RE: S/D 00-13 -- Final Plat of CHISHOLM CREEK 2ND ADDITION

RE: S/D 00-13 -- Final Plat of CHISHOLM CREEK 2ND ADDITION

S/D 00-13 -- Final Plat of CHISHOLM CREEK 2ND ADDITION

CASE NUMBER: S/D 00-13 -- CHISHOLM CREEK 2ND ADDITION

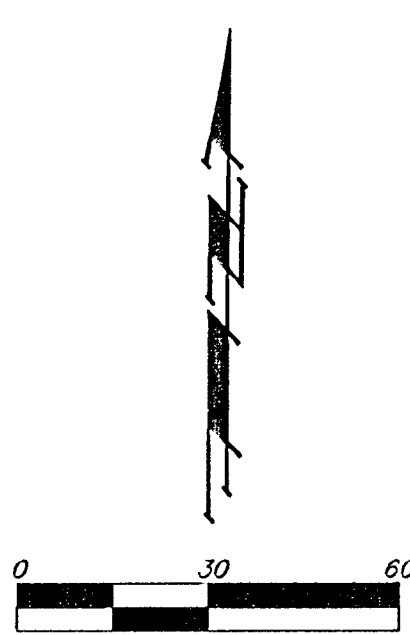
- E. The described distance and bearing for the southeastern property line as referenced in the legal description of the plat's text needs to be included on the face of the plat.

- F. It is recommended that the utility easements be set back from the south and east property lines appropriately to protect existing tree rows.

- G. If platted, the building setback may be a minimum of 20 feet to conform with the NR District zoning standards.

- H. The Fire Lane easement and the Declaration of Condominium Line needs sufficient ties to locate it definitely with respect to the subdivision.
- I. The following note needs to be removed under the Bench Mark: "Note: Minimum building pad elevation requirements will be established on the final plat."

- J. The plat's text shall include language that a drainage plan has been developed for the plat and that all drainage easements, rights-of-way, or reserves shall remain at established grades or as modified with the approval of the applicable City or County Engineer, and unobstructed to allow for the conveyance of stormwater.

As requested, the Applicant has increased the utility easements to 20 feet along the east and south property lines.
